BOGGABRI COAL
OPERATIONS
PTY LTD

RE: BOGGABRI MOD5 - SUPPLEMENTARY INFORMATION REQUEST

We provide the following information in response to your supplementary information request dated 6th June 2016.

Figure 6.2: Modelling source locations for Year 5

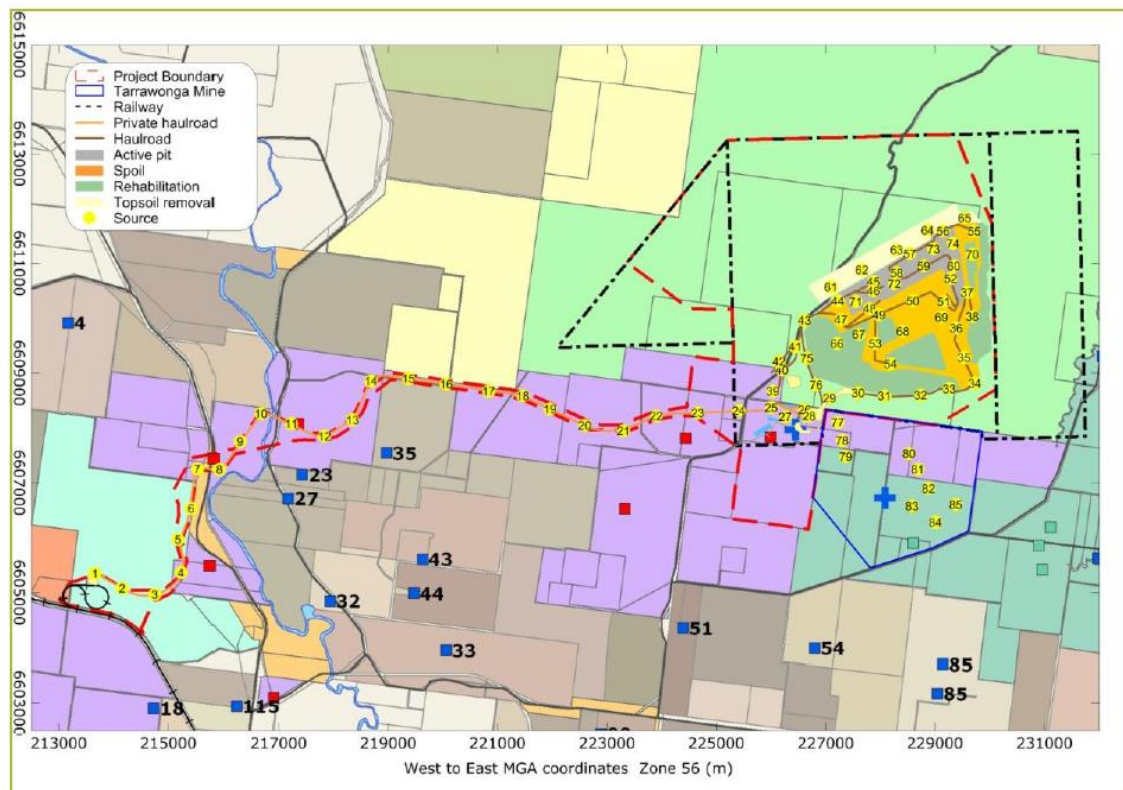
3. Describe the changes in assumptions for haul road intensity between the 2010 EA and MOD5?

There are no changes in assumptions for haul road intensity between the 2010 EA and MOD5. The assumptions for the predicted haul road intensity in the 2010 EA Air Quality Impact Assessment (Pae Holmes 2010) are provided in the Table 2 (Year 5, 2016). The assumed source allocation and haul road routes in the 2010 EA Air Quality Impact Assessment (Pae Holmes 2010) for Year 5 (2016) are provided in Appendix B.
